Key Documents Related to the Recirculation of Portions of the Draft Environmental Impact Report

Horizon West Transmission, LLC's Original Comments on the Draft Environmental
Impact Report

Re: Comments of Horizon West Transmission, LLC on the Draft Environmental Impact Report for the Estrella Substation and Paso Robles Area Reinforcement Project, December 2020 (California State Clearinghouse No. 2018072071)

Figure 2-18.
Ultimate Substation Buildout

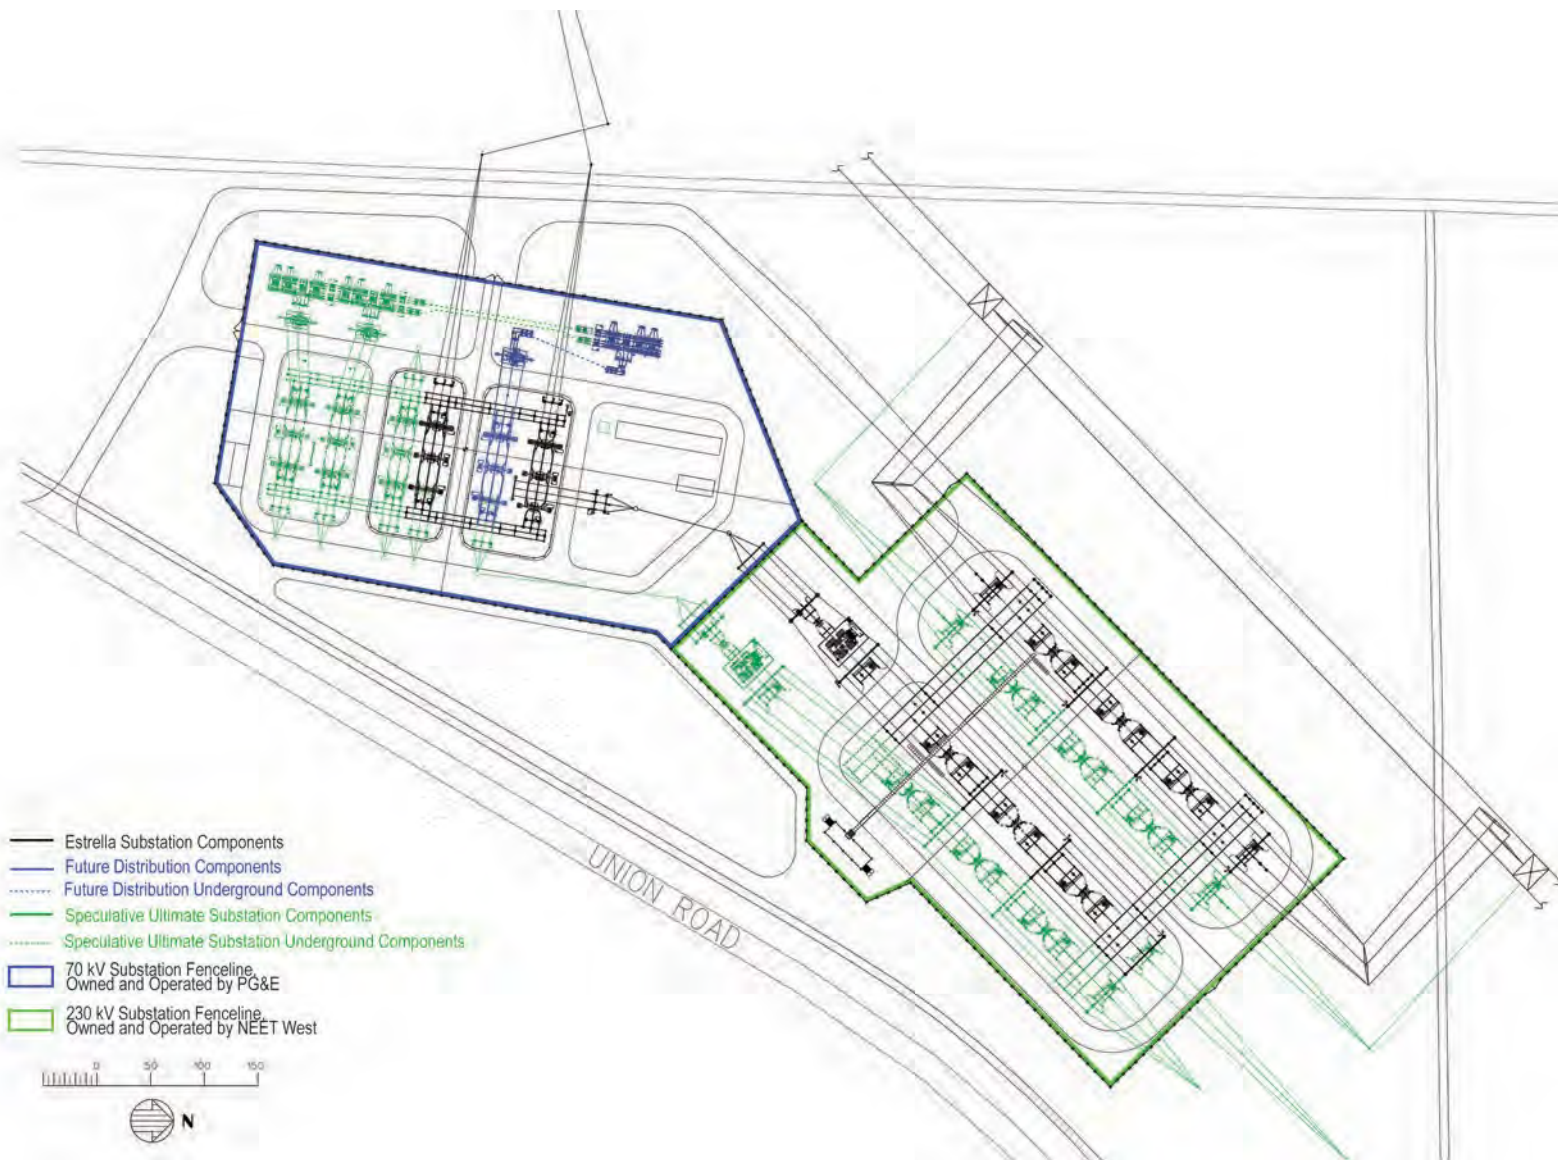
2-57	The additional 70/21 kV transformers that may be installed to support additional distribution feeders are assumed to include secondary containment, as necessary to contain spills of any stored mineral oil.	Please revise text as follows: The additional 70/21 kV transformers that may be installed to support additional distribution feeders are assumed to include secondary containment, as necessary to contain spills of any stored mineral oil.
2-59	Figure 2-18	Replace figure with new substation layout

Figure 3: Cancer Risk Isopleth Map, Scenario 1 (Tier 4 Final Engines)⁸³

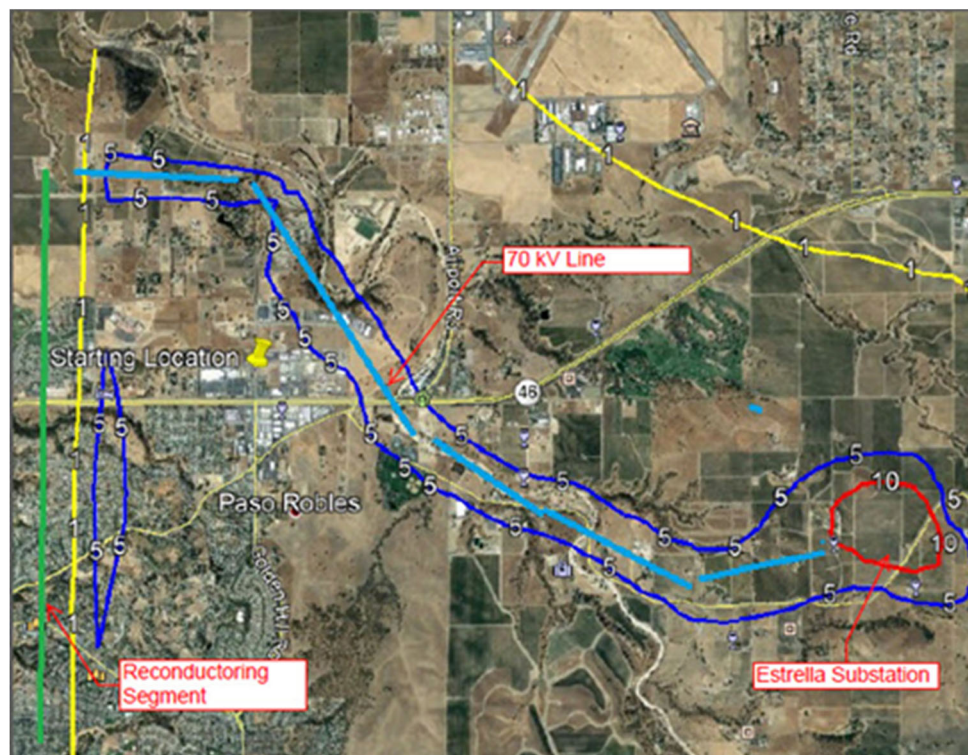
The cancer risk results for Scenario 1, which used the DEIR's DPM construction emissions based on 100% Tier 4 Final engines, are summarized in Figure 3.⁸² The cancer significance threshold is 10 cancer cases in one million exposed, or 10 in one million. The dark blue isopleth line corresponds to a cancer risk of 5 in one million, which is less than the cancer significance threshold.

Cancer risks only equal or exceed the significance threshold (red isopleth in lower right-hand corner of Figure 3 in the vicinity of the Estrella Substation). The PEA reports several residences within this isopleth. Table 1. Thus, if all Tier 4 Final engines are used for construction, cancer risks would only be significant in the vicinity of the Estrella Substation, requiring additional mitigation during construction of the Substation, such as mandating the use of biodiesel fuel in all construction equipment. However, the DEIR does not require all Tier 4 final engines or the use of biodiesel fuel.

Figure 4: Cancer Risk Isopleth Map, Scenario 2 (Tier 2 Engines)⁸⁴

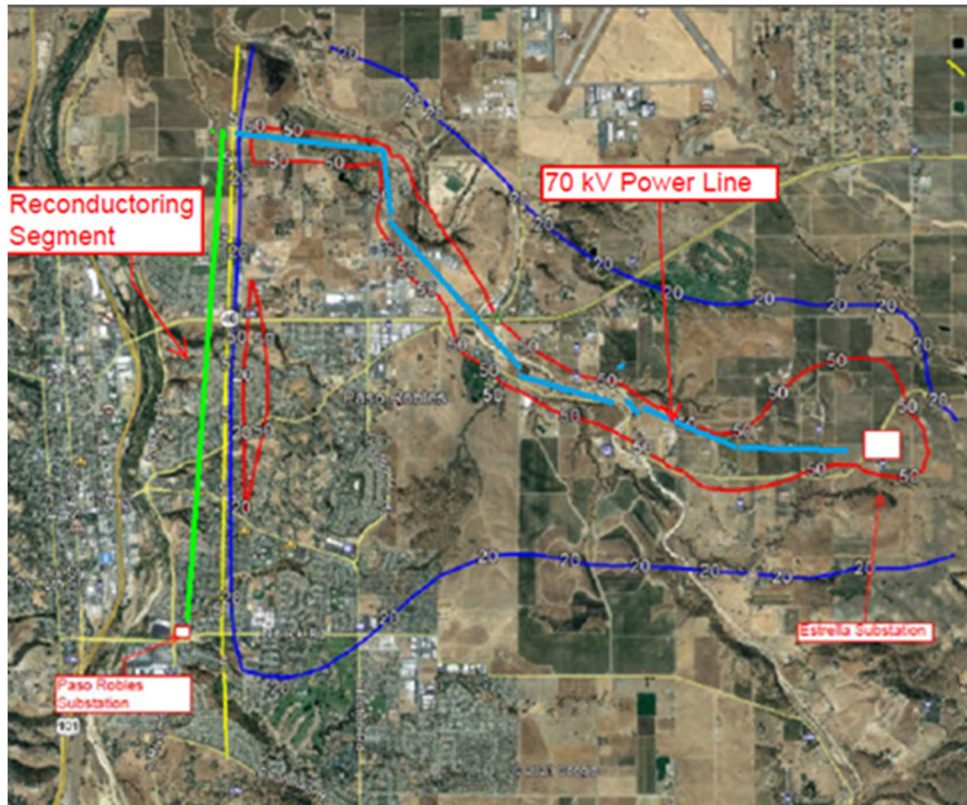
The cancer risk results for Scenario 2, which is based on the use of all Tier 2 construction equipment, as allowed by the DEIR (which only encourages an increase in Tier 3 engines, but does not require them), is summarized in Figure 4. The red isopleth line corresponds to a cancer risk of 50 in one million. The dark blue isopleth line corresponds to a cancer risk of 10 in one million. All sensitive receptors within these isopleths will experience significant cancer risks during construction.

Figure 5: Cancer Risk Isopleths for Scenario 2, Showing Homes East of the Reconductoring Segment⁸⁶

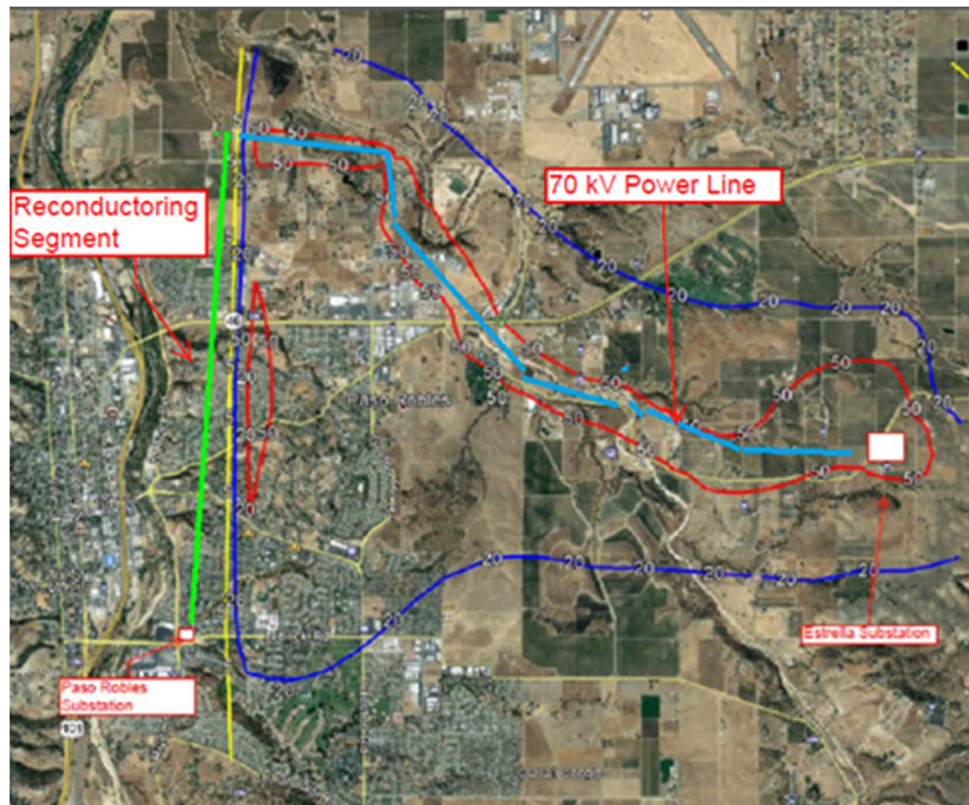
Figure 5 shows a close-up view of the area east of the reconductoring segment. This figure shows hundreds of homes within the 20 to 50 cancer cases per million isopleths. These are highly significant cancer risks, two to five times higher than the significance threshold of 10 in one million, requiring mitigation. These risks can be

mitigated by requiring the use of all Tier 4 construction equipment and diesel particulate traps (soot filters)⁸⁵.

Figure 8: Ambient Construction NO_x Concentrations (ug/m³), Scenario 1⁹⁴

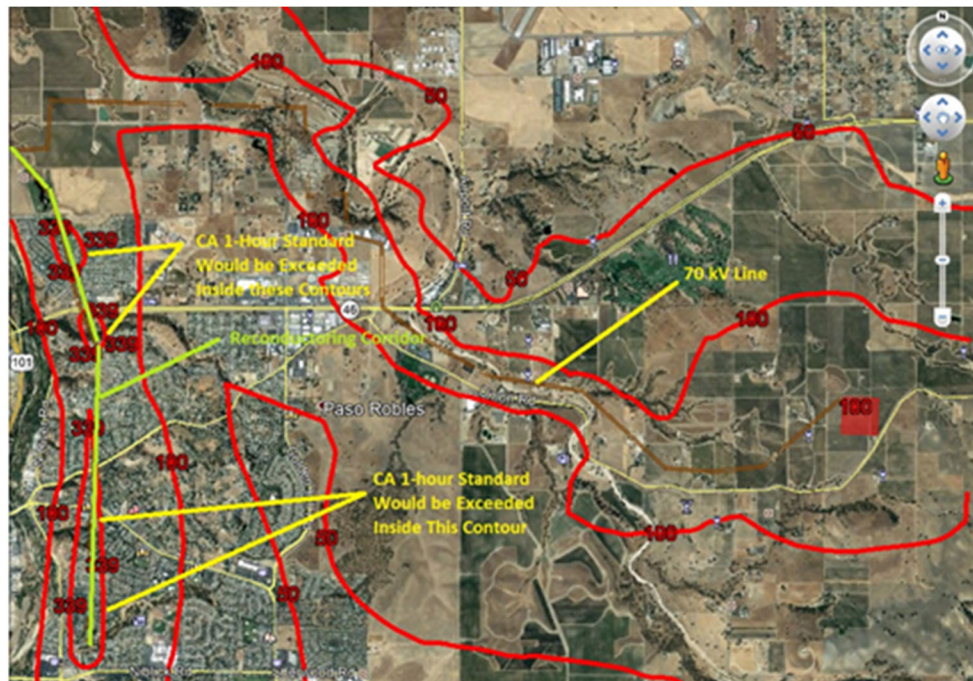
The results of modeling the DEIR's construction NO_x emissions are shown in Figure 8. This figure indicates that the California 1-hour NO_x standard would be exceeded along the reconductoring line. This is both a significant air quality impact (violation of a state ambient air quality standard) and a significant health impact, as the state NO_x standard was set to protect public health.

Figure 9: Ambient Construction NOx Concentrations, Scenario 2⁹⁵

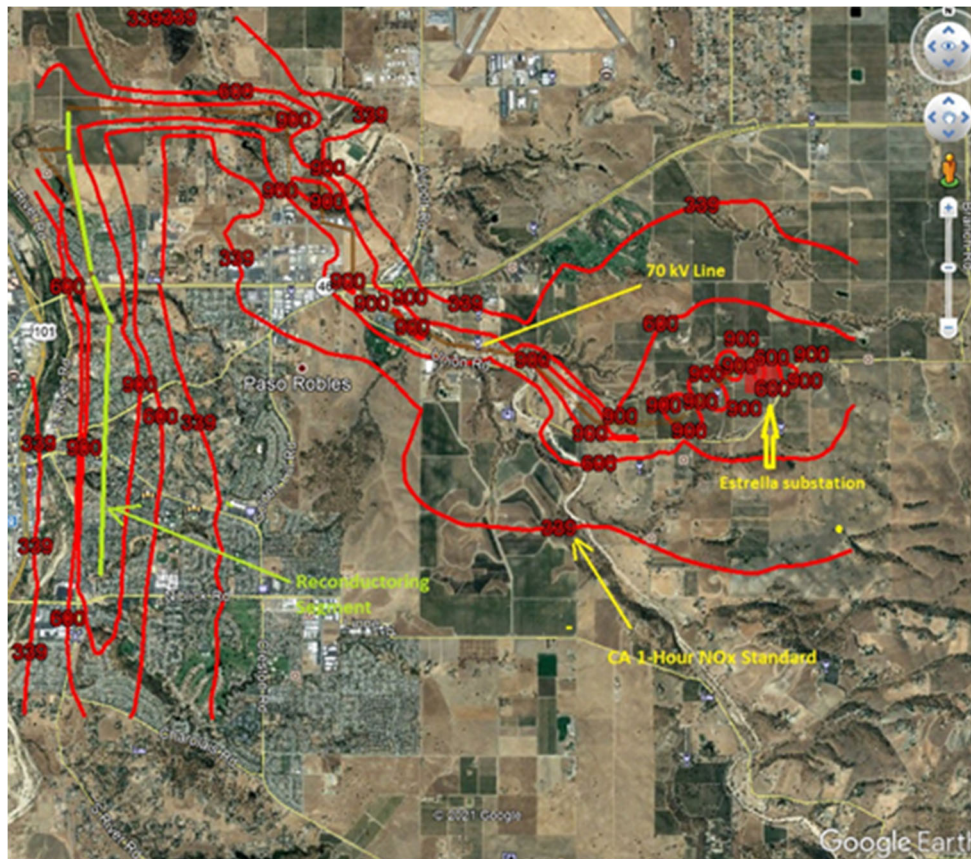
The result of modeling construction NO_x emissions assuming the use of all Tier 3 construction equipment are shown in Figure 9. This figure shows that the California 1-hour NO_x ambient air quality standard would be reach 900 ug/m³, nearly a factor 3 higher than the California 1-hour ambient air quality standard, in the vicinity of all Project components in locations with numerous sensitive receptors. This is both a significant air quality impact (violation of a state ambient air quality standard) and a significant health impact, as the state NO_x standard was set to protect public health.

**Figure 16: Segments of Transmission Line (in blue)
Proposed for Undergrounding (in pink)**

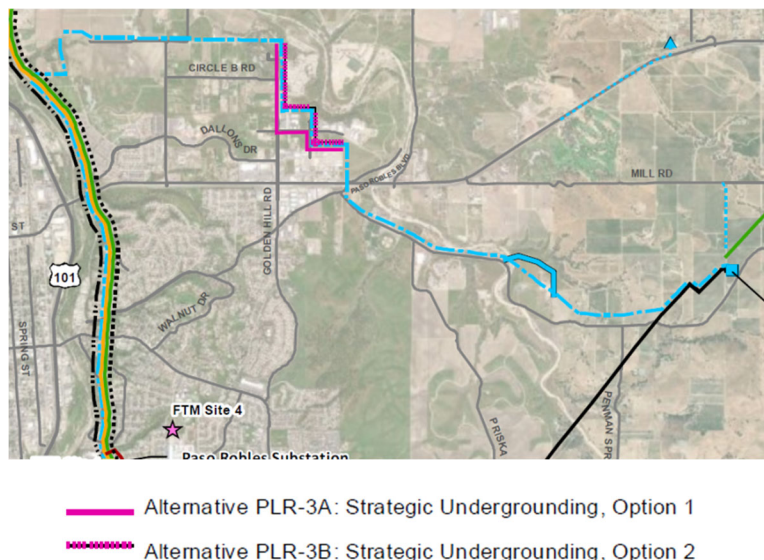
The DEIR included two alternatives to the aboveground transmission line, Alternative PLR-3A and PLR-3B to underground small portions of it, as shown in Figure 16. However, the DEIR failed to adopt either or explain why they were not adopted as they reduce otherwise highly significant aesthetic, public health, and biological impacts in the area as well as the risk of fire.

At a minimum, Alternative PLR-3, strategic undergrounding, should be adopted, as this segment of the transmission line passes through the Golden Hill Road area north of SR 46, which has the greatest potential for public health, aesthetic, biological, and other environmental impacts. Figure 16.
